Appl. No. 09/992,231 Amdt. dated January 9, 2006 Reply to Office Action of October 7, 2005

Amendments to the Drawings:

Drawing Amendments to Fig. 2 and Fig. 8

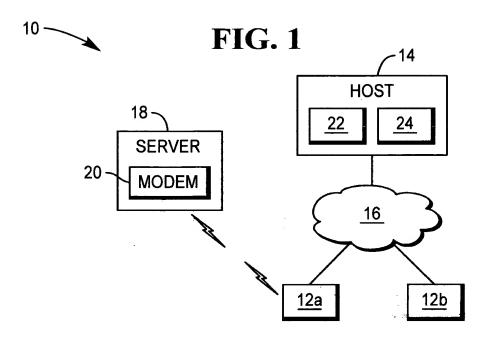
Included in the amendment are an "Annotated Sheet Showing Changes" and a "Replacement Sheet" for Figs. 2 and 8. Fig. 2 has been amended to add connections between both deposit module 42 and internal bus 50 and cash dispenser module 44 and internal bus 50 consistent with the discussion of these figures in the specification. See, for example, page 7, lines 26-27. Similarly, Fig. 8 has been amended to add connections between both deposit module 442 and internal bus 450 and cash dispenser module 444 and internal bus 450.

During the preparation of this response, several drawing errors were noted and are now being corrected. Support can be found for these drawing errors, for example, at page 7, lines 26-27 and at page 14, lines 13-14 of the specification. At page 7, lines 26-27, the specification

recites, "All of the modules within the ATM 12 are interconnected by an internal bus 50 for securely conveying data."
